UNITED STATES PATENT AND TRADEMARK OFFICE

10/585,665

Wolfgang Kramer

Office Action Summary	Application No. 10/585,665	Applicant(s) KRAMER, WOLFGANG	
	Examiner Leonard R. Leo	Art Unit 3785

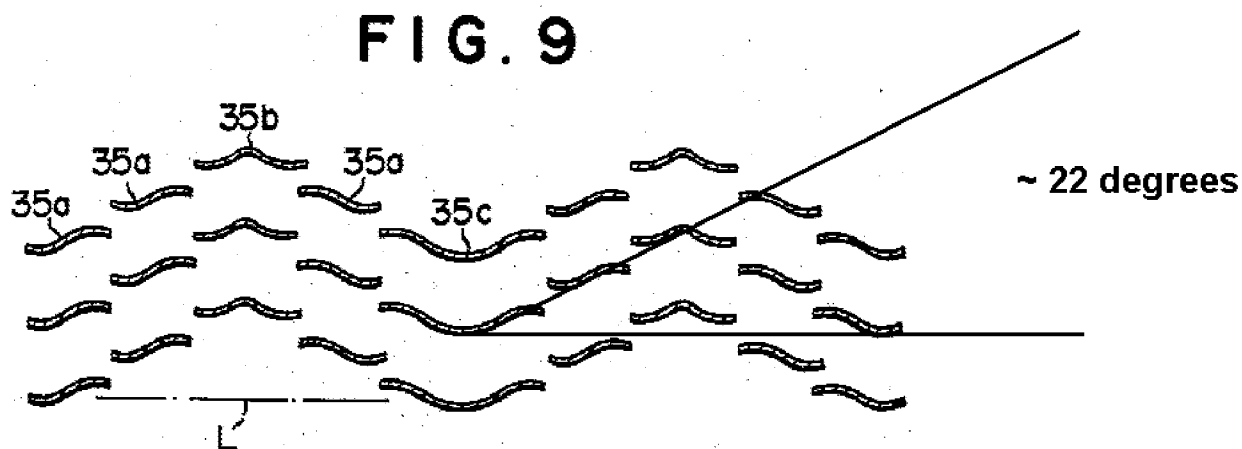
Regarding claim 12, similar to claim 1, the recitations of "an incident flow-angle," "a flow-off angle," and "a deflecting angle" in lines 11-12 are indefinite. The claim requires structure or perspective reference to define how the angles are determined, i.e. straight lines, central plane, etc. Further, claim 12 recites the limitation "the incident flow-*off* angle" in line 13. There is insufficient antecedent basis for this limitation in the claim.

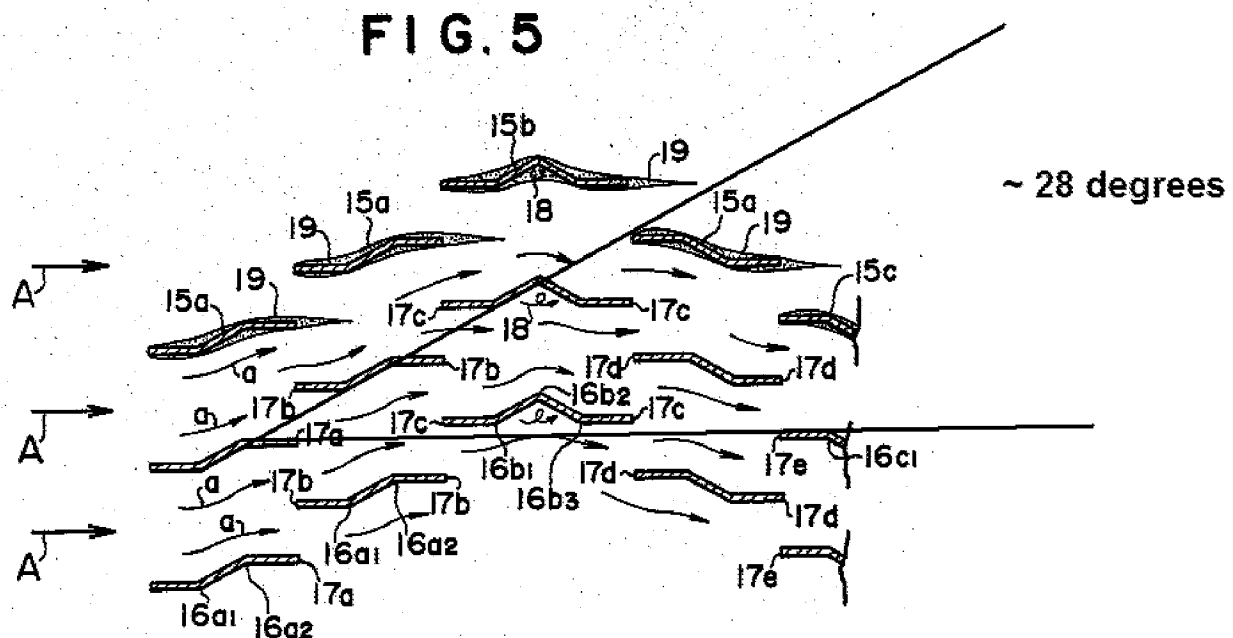
Hatada et al (Figure 10) discloses a fin comprising gills 45 having a S-shaped cross section with an incident-flow angle approximately the same size as a flow-off angle of zero degrees and a deflecting angle of about 22 degrees (as permissibly gleaned from the drawings below), but does not disclose flat tubes.
